**CITY OF ISSAQUAH
MAJOR DEVELOPMENT REVIEW TEAM
ISSAQUAH HIGHLANDS PRELIMINARY PLAT
DEVELOPMENT AREA 1
STAFF REPORT**

February 28, 2012

Project: Issaquah Highlands Preliminary Plat
Division 95
PP12-00001

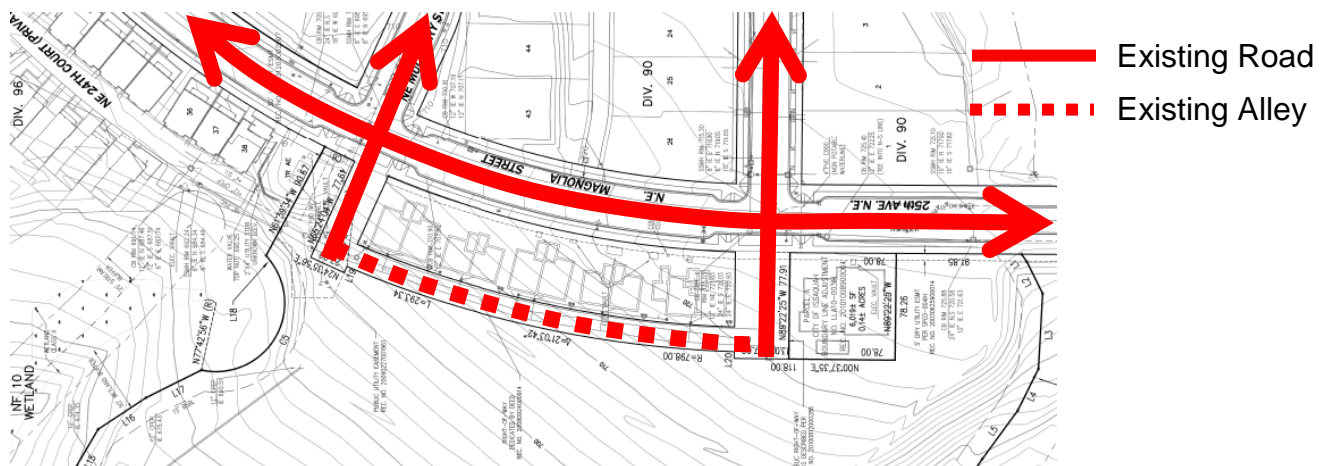
The off-site sewer connection shown on the plans must be extended to the publicly-owned and previously approved sewer pipeline adjacent to Division 96, as the pipe termination shown on the plans falls short of the public storm pipeline by several hundred feet and is shown connecting to an unpermitted section of pipe. **[Condition 20]** This connection must cross a section of wetland and must either be bored under the wetland and buffer, or must be preceded by a Critical Area Study that identifies and mitigates the impacts of construction and maintenance.

- 19 Sewer improvements within the BPA power line easement shall be approved in writing by the BPA.
- 20 The off-site sewer connection shown on the plans must be extended to the publically-owned and previously approved sewer pipeline adjacent to Division 96. The improvements shall be approved by the BPA. This condition will be enforced during Utility Permit Review.

Woonerfs

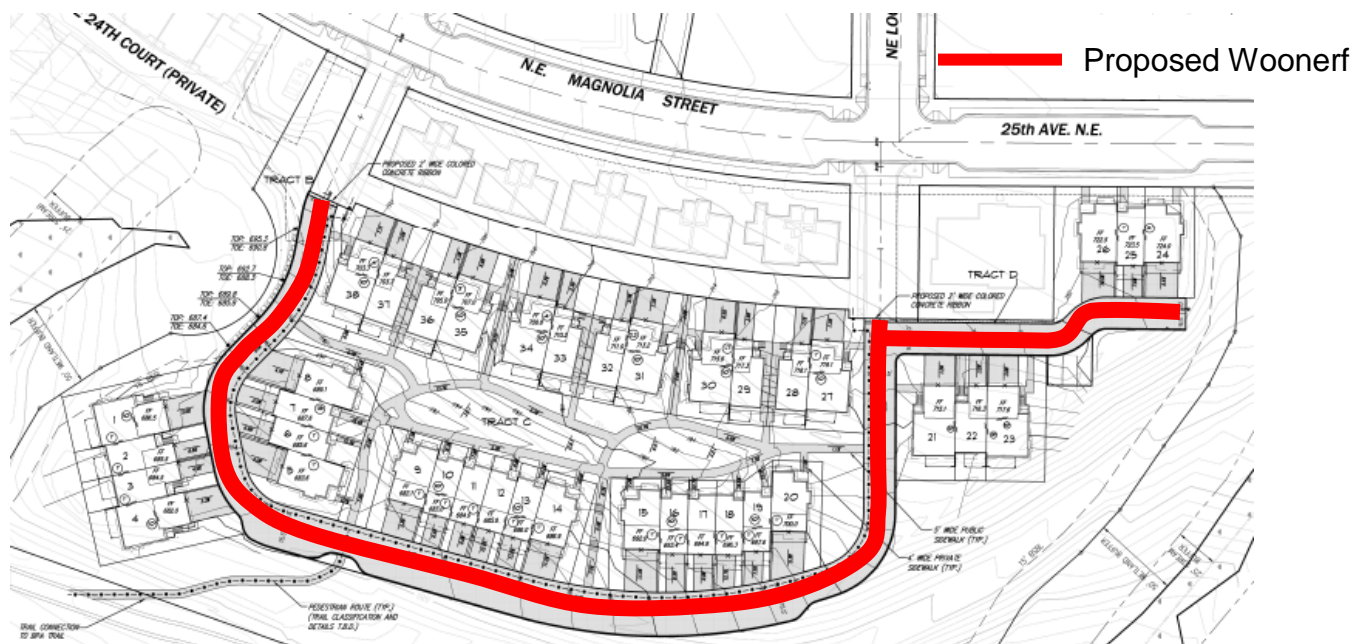
All of the proposed vehicular access is provided by woonerfs, except for the existing alley behind Lots 27-38. Woonerfs will furnish both pedestrian and vehicular circulation with a shared, non-asphalt surface. Though this discussion is provided under Appendix H, Roads, there are no specific dimensional standards for woonerfs, only general ones, which are discussed under Appendix U, Parks, Plazas, and Woonerfs; however, since they provide all proposed vehicular access they are reviewed here.

Woonerfs are designed and approved on a case by case basis. To ensure Eastside Fire and Rescue (EF&R) access to the homes, there are certain minimum width constraints that must be applied. That is, woonerfs that provide through traffic must be at least 18 ft wide and they additionally may have 7 ft of parallel parking. And street trees shall be provided along the woonerf to further enhance its character. **[Condition 21]**

Where woonerfs deadend, additional review criteria are necessary to ensure EF&R as well as the waste purveyor have necessary access. A deadend woonerf must meet the following length restrictions: a minimum of 15 wide for the first 150 feet of woonerf, no more than three homes served by the deadend woonerf, and all portions of the homes within 150 ft of the looped woonerf, as the hose lays. While there are six homes on the deadend woonerf, only Lots 21-23 receive EF&R service from it; Lots 24-26 will be served from 25th Ave NE. The proposed deadend woonerf is 18 feet wide which is appropriate since six residences will use it for their vehicular access.

Lot Design

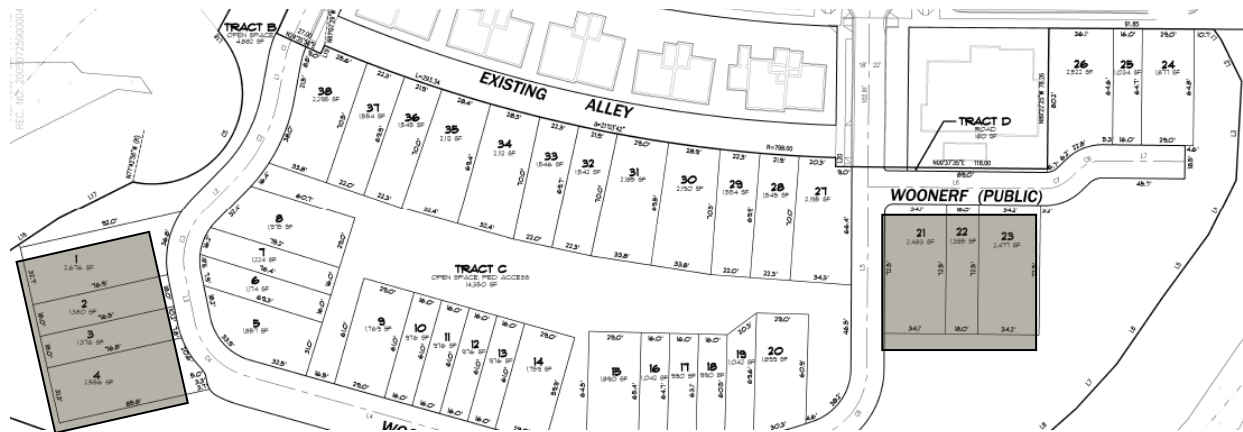
The Development Agreement places importance on creating a pedestrian friendly and socially gregarious public realm in which houses address the street and auto dominance is reduced. The design of narrow, front loaded lots (Lots 1-4 and 21-23 – see plan below for location) increases the frequency of vehicular/pedestrian conflicts and potentially diminishes the relationship between the house and the street as well as diminishing the pedestrian dominance expected of a woonerf. It is necessary to limit the width of the on-site driveways to ensure the residences have a strong relationship with the street, “...where the whole composition of streets, trees, parkways, walks, front yards and front porches define and contain a common space for residents to stroll, meet, play, and socialize.” [Condition 30]

Open Space Design

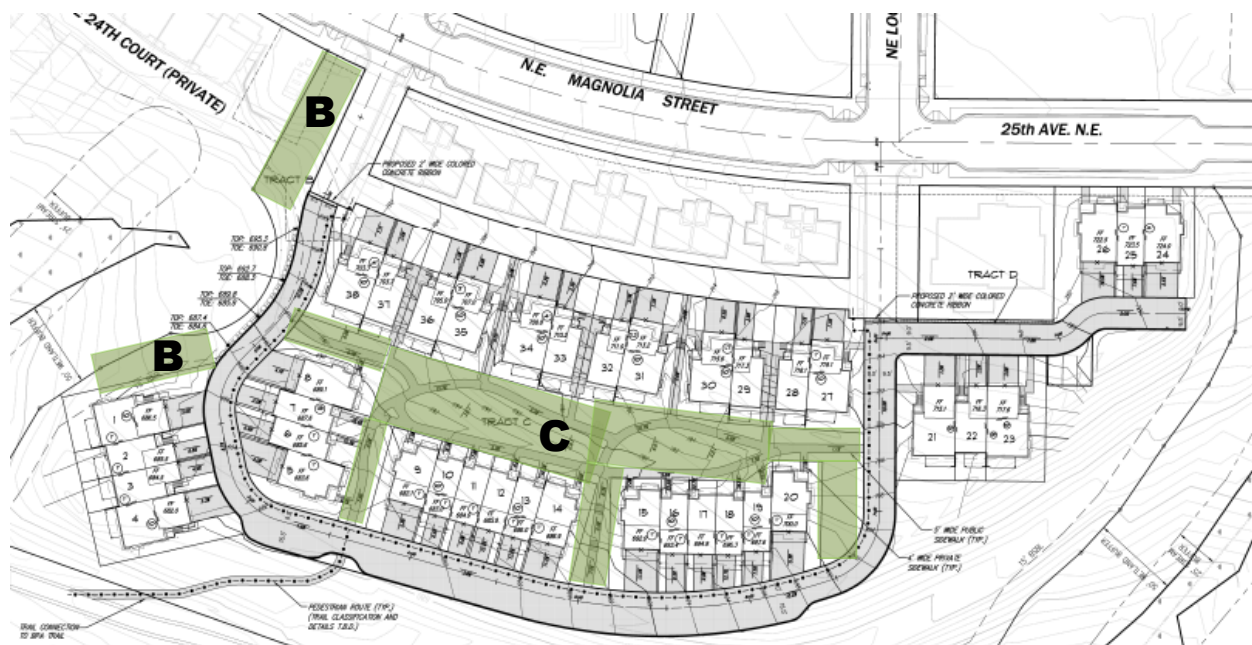
The primary shared open space is Tracts C, and possibly B. Tract C in particular is geared to provide gathering and recreation space, and become a focal point for activity since individual lots are small and proposed house layouts leave little room for private recreation space. Though the plat is designed for fee simple lots, as townhomes, the proposal will function like a multi-family project. Specific review of the proposals will occur with the ASDPs for these tracts; however, based on the following excerpts from the Development Agreement, the tracts should be modified to incorporate children's play and community gathering/facilities.

As Tract C is the only open space for recreation, it should provide at least one relatively flat area of reasonable size to accommodate play as well as adult activities than need flat areas, and none are shown. This an excellent opportunity to provide the diversity of spaces discussed in the Development Agreement. Somewhere on site, preferably in Tract C, there should be a minimum of 1000 sq.ft. of generally flat area, i.e. 2-3% max slope; this is about 10% of the Tract C’s central space, leaving room for landscape and grade change. **[Condition 32]**

- 31 Incorporate children as an integral user of the open space, including varied opportunities for children's play. This will be reviewed with Utility Permits as well as the Administrative Site Development Permit for the open space Tracts.
- 32 Somewhere on site, preferably within Tract C, the plat will provide a relatively flat area of a minimum 1000 sq.ft. Flat is defined as 2-3% maximum slope. This will be reviewed with the ASDPs for these tracts as well as Utility Permits.

Service and Mechanical Area Screening

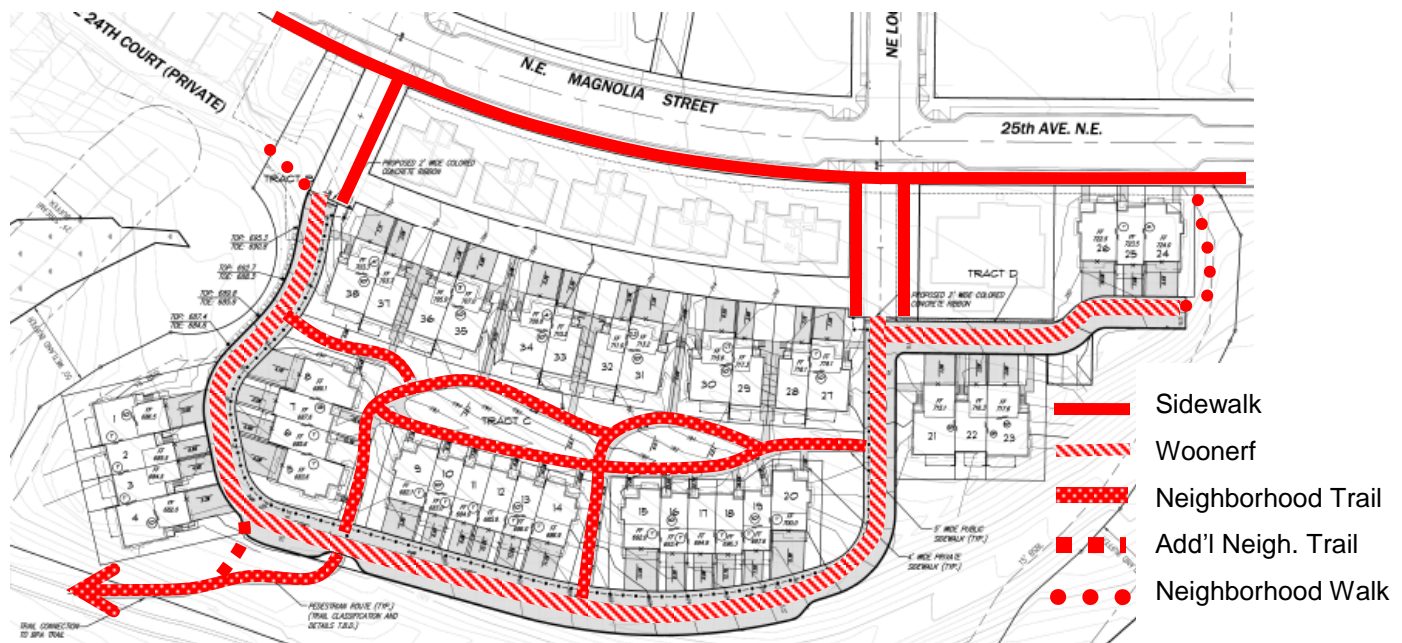
Access and equipment associated with wet and dry utilities are a necessary part of a functioning community. However, their presence does not enhance the overall residential character and objectives. Screening and location can reduce the impact of these necessary elements. **[Condition 36]**

- 36 Design and placement of the above ground facilities, such as buildings, walkways, significant plant materials, etc... shall take priority over the convenient location of utilities, unless this would significantly compromise the function of the utilities. On construction permits, utilities and their necessary easements shall be shown. This will be reviewed with Utility Permits.

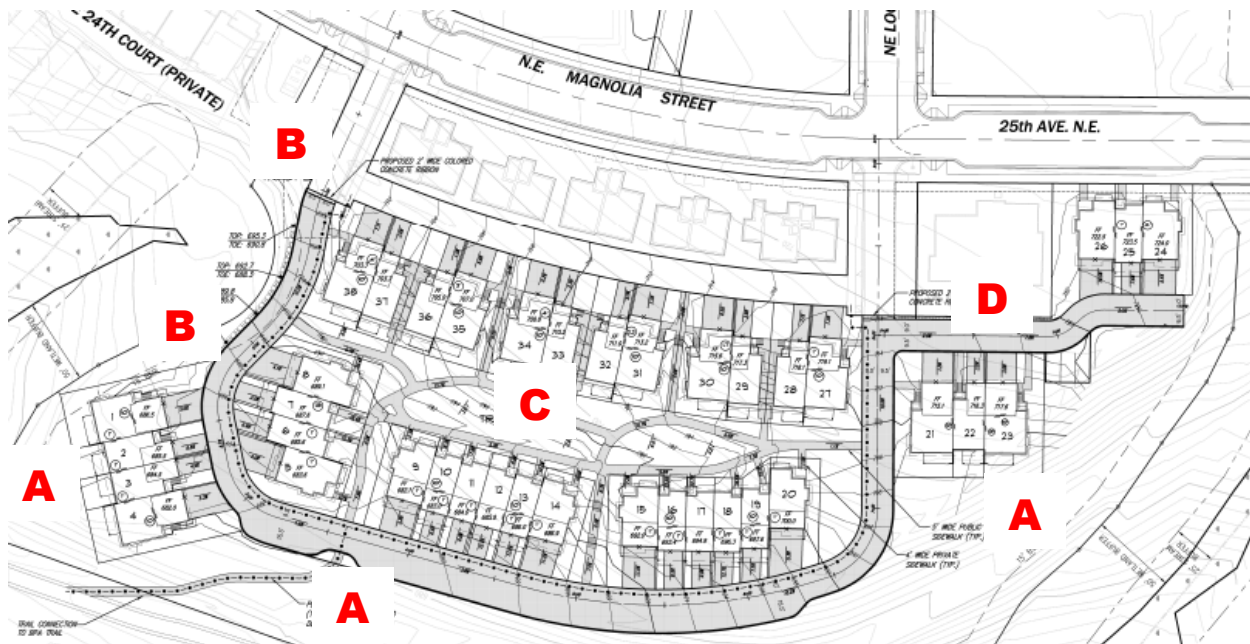
Neighborhood Walks are short, small-scale walkways designed to provide recreational opportunities, alternative routes, or shortcuts. They are appropriate to provide pedestrian connectivity from deadend vehicular facilities. The walk is a 4 ft wide trail with 3 ft landscape borders which should fit in these locations.
